TVA-SQN-TS-06-04

**SEQUOYAH NUCLEAR PLANT (SQN) - UNITS 1 AND 2 - TECHNICAL SPECIFICATIONS (TS) CHANGE 06-04, "MONITORING OF CONTROL OR SHUTDOWN ROD POSITION BY AN ALTERNATE MEANS"**

TENNESSEE VALLEY AUTHORITY (TVA)  
SEQUOYAH NUCLEAR PLANT (SQN)  
UNITS 1 AND 2

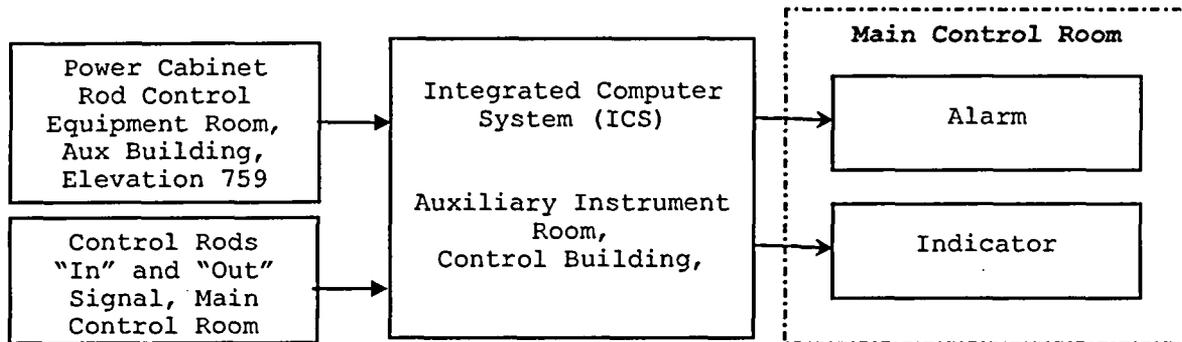
TVA plans to utilize the plant computer to monitor the stationary gripper and lift coil voltages. Monitoring the inoperable ARPI in this manner will allow for historical data retrieval and will also allow the use of the existing rod deviation alarm. The "Rod at Bottom" status light and the "Rods at Bottom" annunciator for the affected control rod may be disabled. A simplified schematic of the monitoring circuit is provided below:
